INTERNATIONAL STANDARD ISO 9100-2:2005 TECHNICAL CORRIGENDUM 1

Glass containers — Vacuum lug finishes —

Part 2: 33 medium

TECHNICAL CORRIGENDUM 1

Figure 1 — Thread construction and enlarged view section B-B

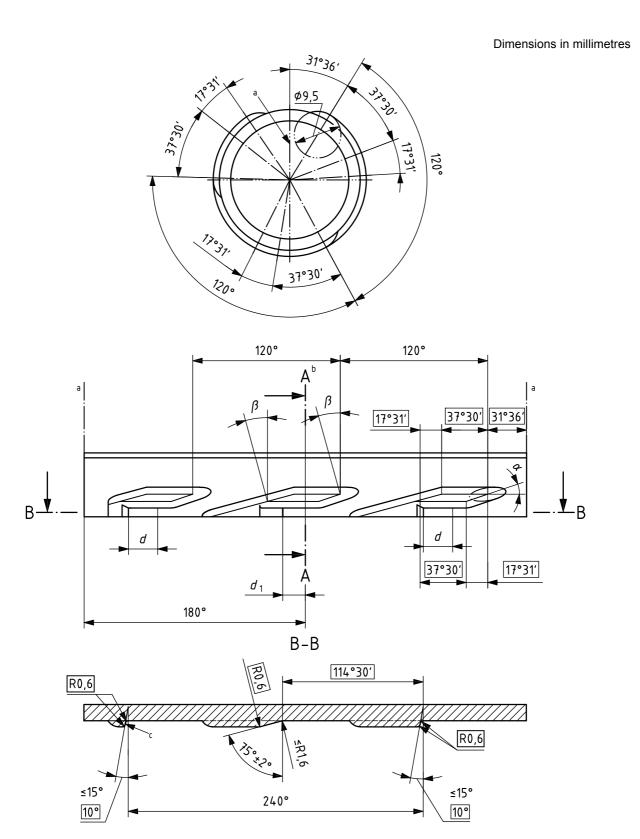
Page 2, Figure 1

Replace Figure 1 with the following figure. (In the enlarged view section B-B, the arrow for footnote "c" has been moved to the right of the stop face.)

^c The stop faces on the leads have a cap stopping function. Thus they shall be sharp-edged and as perpendicular to the E-wall as possible. The radii of the stop faces should be the same as of the mould. A punctual replacement of moulds is necessary to prevent worn contours.
